**Hydro Tasmania**  
*the renewable energy business*

### **2009 Market Ancillary Services Specification consultation**

## First MASS consultation (Tasmanian Frequency Operating Standards Change)

### Issue 1: Shape of the standard frequency ramp

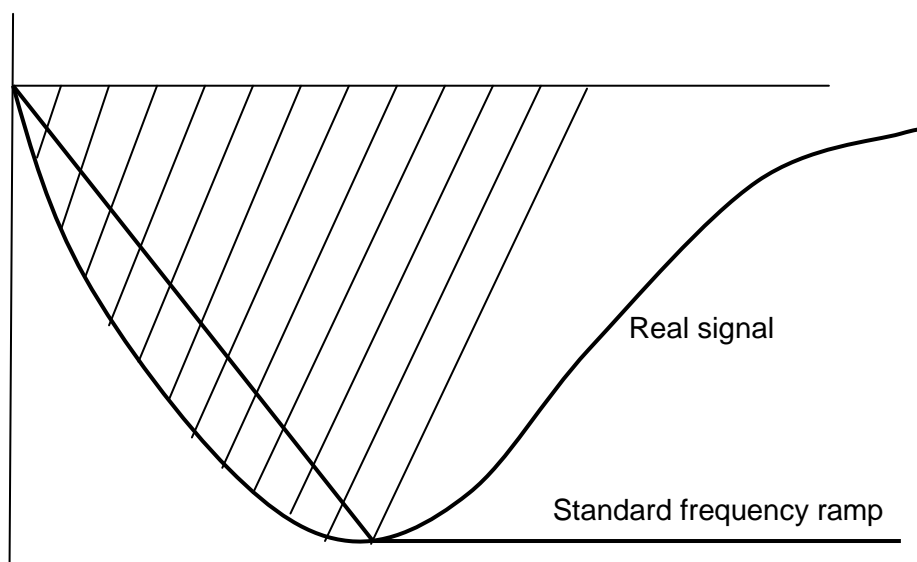
In Tasmania, fast FCAS is in short supply. Any under estimation of the fast FCAS capability of machines leads to sub-optimal dispatch. The shape of the standard frequency ramp does not reflect the shape of the frequency trace following a disturbance. In Tasmania the shape of the frequency trace is basically that of a half sinusoid. The time to reach the peak varies typically in the range 5-7s. The current standard frequency ramp for raise reaches its peak at 4.9 s which is at the low end of the time to reach the peak frequency excursion, however it under-predicts the “area under the curve”, leading to an under-prediction of the fast FCAS capability as illustrated below:

The FCAS capability is assessed according to a time average. The results will therefore be sensitive to the area under the frequency trace. Two suggestions for improving the accuracy of the capability assessment would be:

- 1) Change the shape of the test signal to better match the real frequency trace; or
- 2) Select the ramp rate such that the area under curve is similar to the real frequency trace.

The same applies to the lower test signal.

## Issue 2: Scaling factor in verification methods for “proportional control”

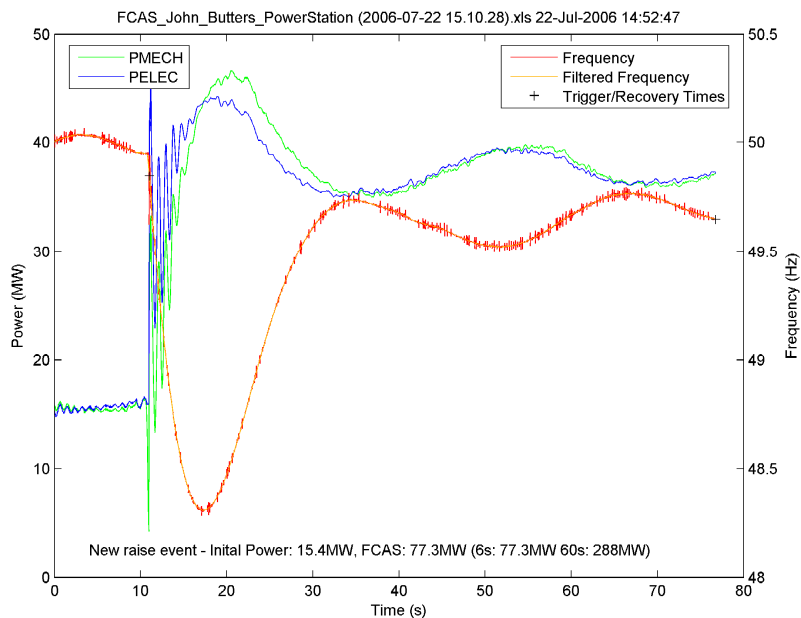
The main problem with the scaling factor as it stands is the large scaling that is applied at the start of disturbances as frequency exits the normal operating band. In Tasmania, the scaling factor for raise and lower services, will be initially 13.3 (2 Hz/0.15Hz under the new Tasmanian Frequency Standards).

Generally with lower disturbances the errors produced by the scaling factor are not obvious in the results because the initial response is normally in the wrong direction, somewhat balancing the over scaling later on. For raise disturbances there is normally a large over estimation of the delivered FCAS. See the example below:

The delivered FCAS was calculated to be 77MW even though the actual change in output was only about 25MW up to 6s.

The scaling factor could be revised by:

- Basing it on the difference between the test signal and the measured frequency, not the reference frequency and the measured frequency. Scaling to the reference frequency produces a roughly 2x over-scale.
- Applying it to the overall result and not the individual samples so that noise and the rotor angle oscillations average to zero.
